CITY of NOVI CITY COUNCIL

Agenda Item 4
October 22, 2018

SUBJECT: Approval at the request of Orville Properties, LLC for Adell Center JSP 18-27 for City Council for approval of a Site Plan for Roads and Utilities, a Wetland Permit, a Woodland Permit and a Site Condominium Plan. The subject property is approximately 22.48 acres and is located at 43700 Expo Center Drive, north of Grand River Avenue and south of I-96 in Section 15. The applicant is proposing to develop the property as a multi-unit commercial development consisting of nine units accessed by a proposed private drive. The existing water tower on site will remain on a separate unit. Approval is contingent on completion of the rezoning of the property through the Planned Rezoning Overlay (PRO) process.

JSP 18-27 ADELL CENTER ROADS & UTILITIES

RESTORATION PLAN

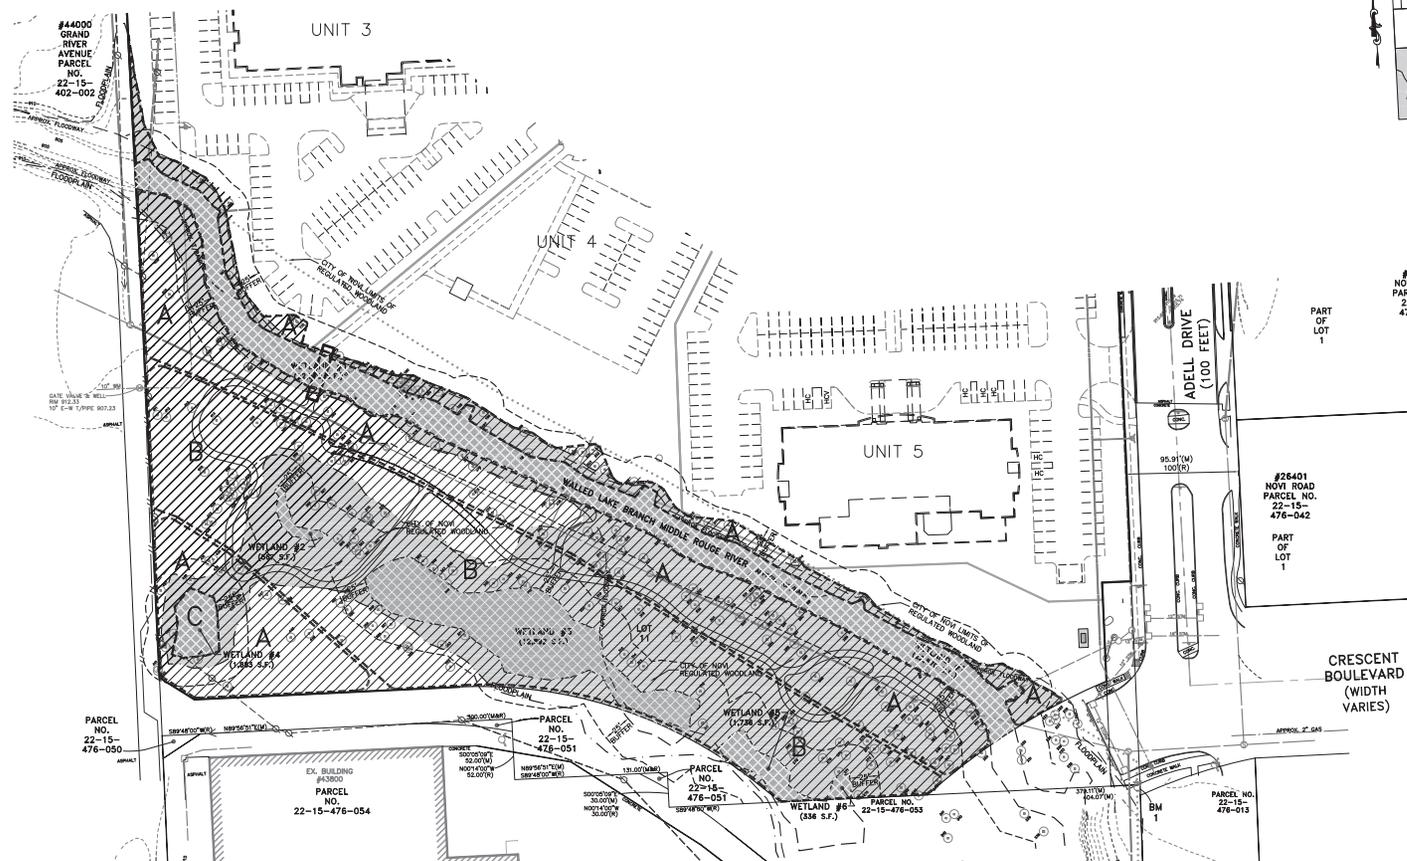
Environmental Consulting & Technology, Inc. (ECT) has completed a review of the Site Enhancement Plan (Sheet 35) for the proposed Adell Center Roads & Utilities project prepared by Greentech Engineering, Inc. dated August 31, 2018 (Plan) ahead of the proposed site development project. The project is located at 43700 Expo Center Drive (Parcel ID 50-22-15-476-045), south of I-96 and north of Grand River Avenue, west of Novi Road in Section 15. The site development plan includes the construction of a mixed-use district with several proposed building sites, associated parking, utilities and underground stormwater detention systems. The current Plan indicates a total of nine (9) building units, with Unit 4 being a parking lot and gazebo.

The Site Enhancement Plan includes proposed activity within areas mapped City-Regulated Wetlands/Watercourses and City-Regulated Woodlands on the City's Wetlands and Woodlands Maps (see Figure 1). Six (6) wetland areas and a section of the Walled Lake Branch of the Middle Rouge River as well as City-Regulated woodland are located on the southern section of the subject site. The wetlands appear to be regulated by the City of Novi as well as by the Michigan Department of Environmental Quality (MDEQ).

14. A site enhancement plan has been added to the plan set. See sheet 35

8. A conservation easement will be granted over the woodland replacement tree area.
9. A site enhancement plan has been added to the plan set. See sheet 35

Figure 2. Wetland Sketch (provided by BWA).

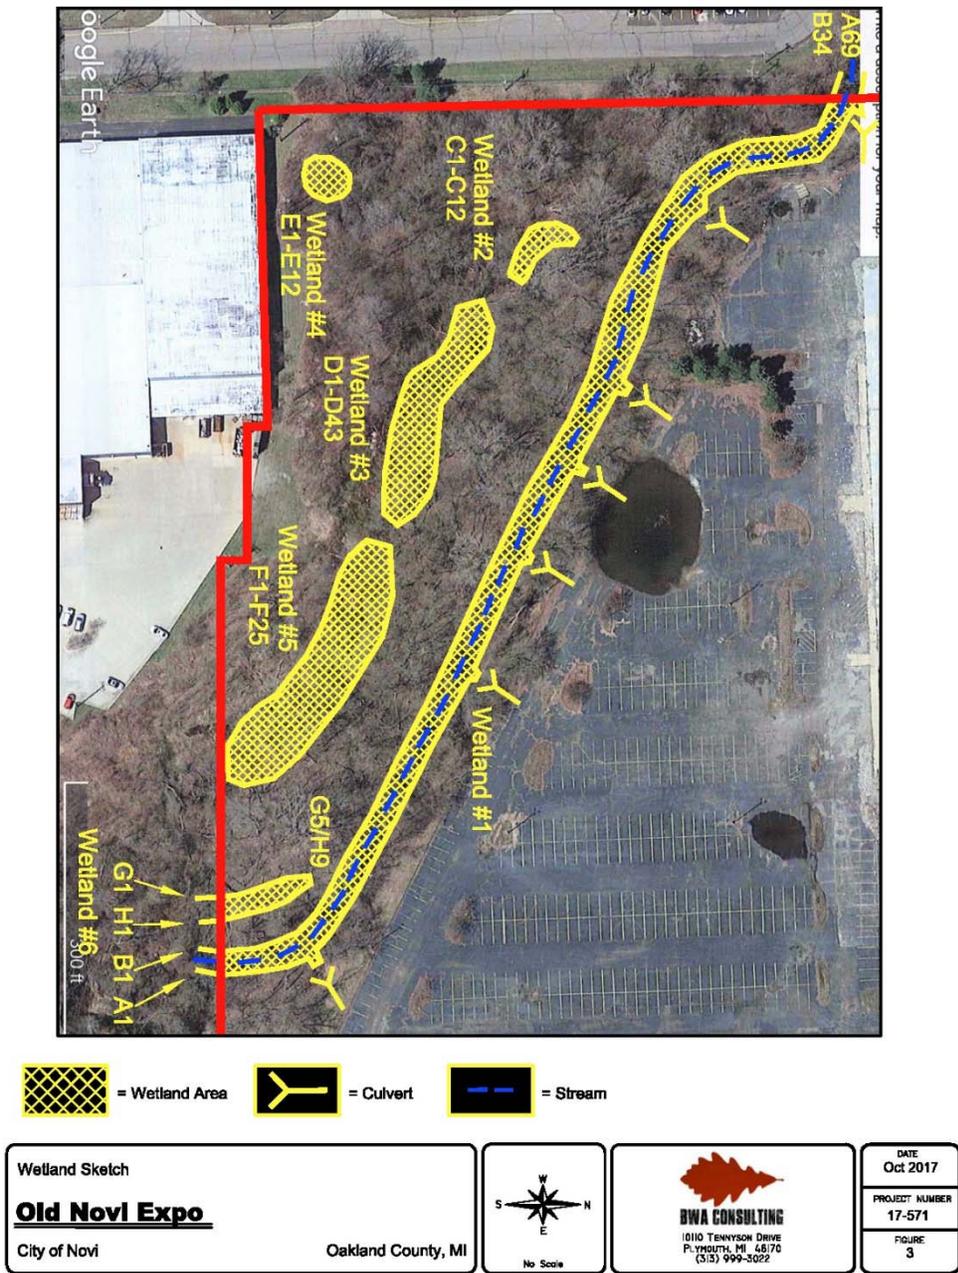
ECT has evaluated the on-site wetlands and believes that they are all considered to be essential/regulated by the City of Novi as they meet one or more of the essentiality criteria (i.e., functions and values) outlined in the City of Novi Wetland and Watercourse Protection Ordinance and regulated by the MDEQ . As noted, the wetlands appear to accurately flagged in the field and appear to be generally indicated accurately on the *Wetland Sketch* provided by BWA (Figure 2, attached).

All six (6) of the on-site wetlands appear to be located within the area depicted as regulated wetland on the City of Novi Regulated Wetland and Watercourse Map (Figure 2). ECT has evaluated each wetland and believes that each wetland is regulated by the City's Wetland and Watercourse Protection Ordinance because all on-site wetlands are located within 500-feet of the Walled Lake Branch of the Middle Rouge River.

Figure 1. City of Novi Regulated Wetland & Woodland Map (approximate parcel boundary shown in orange). Regulated Woodland areas are shown in green and Regulated Wetland areas are shown in blue.

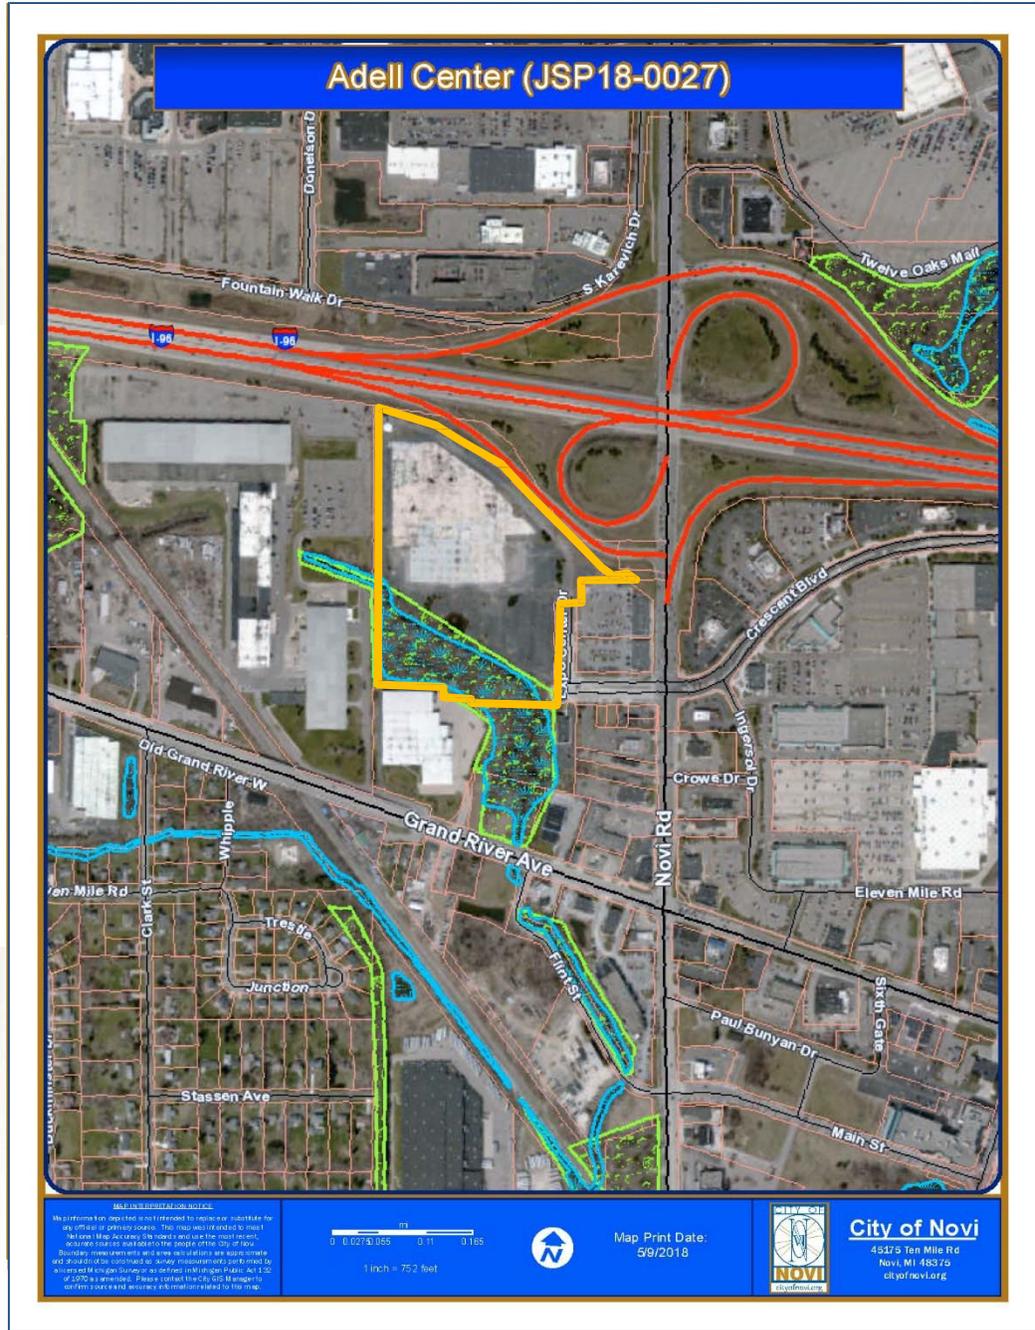
Based on our review of the Plan, Novi aerial photos, Novi GIS, City of Novi Official Wetlands and Woodlands Map (see Figure 1), and on-site evaluation this proposed project site contains areas indicated as Regulated Woodlands as well as Regulated Wetlands. The area of regulated woodland is located in the southern portion of the property (south of the Walled Lake Branch of the Middle Rouge River).
